## Product Change Notification

**1. ECN #:** 285091

- IPBS - .165 DOUBLE ROW SOCKET ASSEMBLY

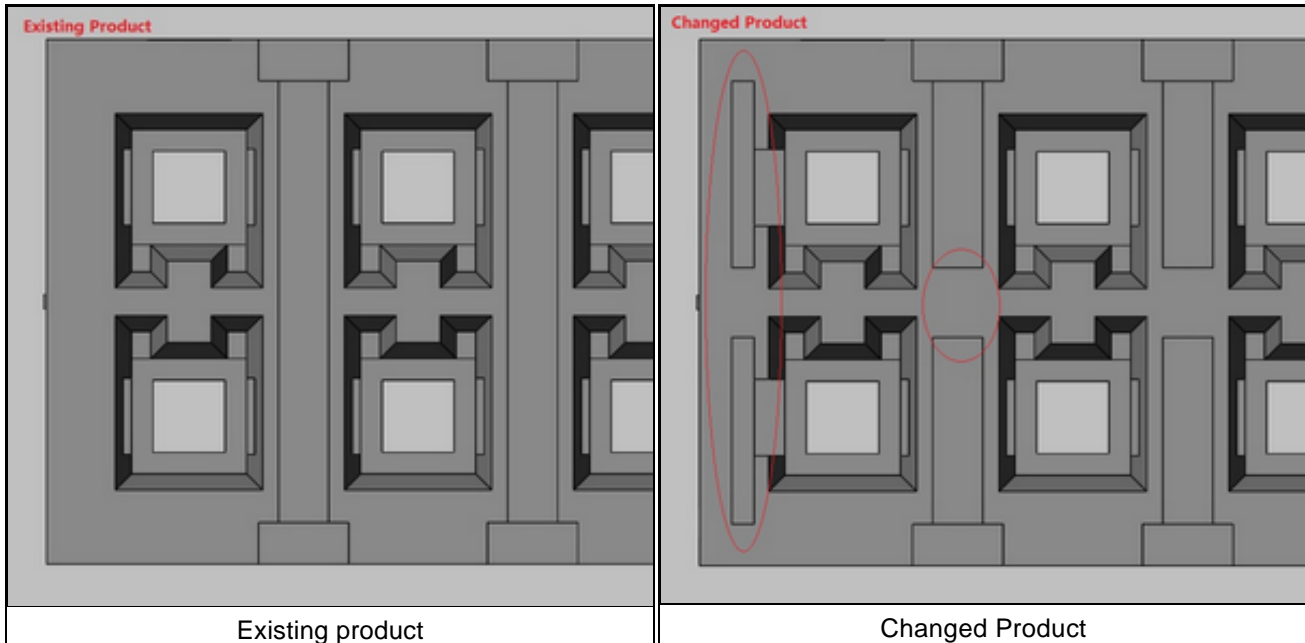
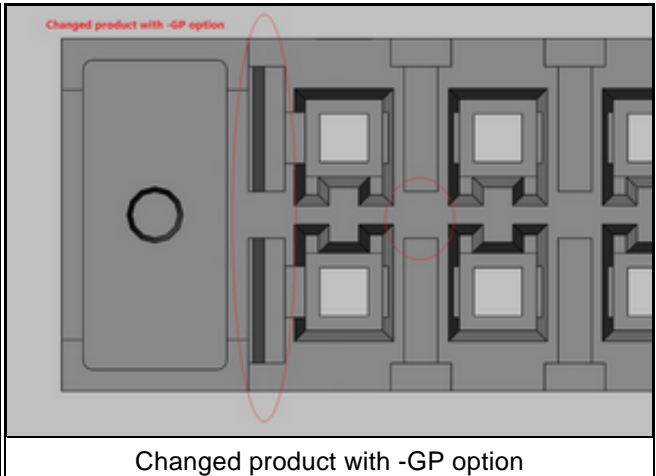
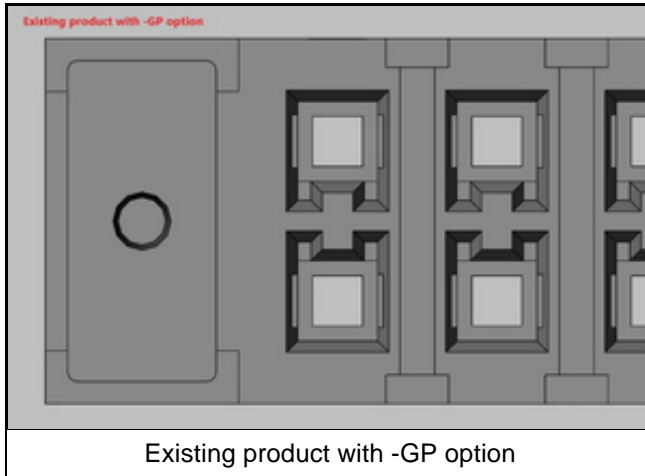
Add void corings on 06 through 15 positions body.

Visual inspection; voids will be noticed on ends of body where prior revisions had no voids; this is a rolling change.

Changes made to improve dimensional consistency.

- Form - this is a Form change.
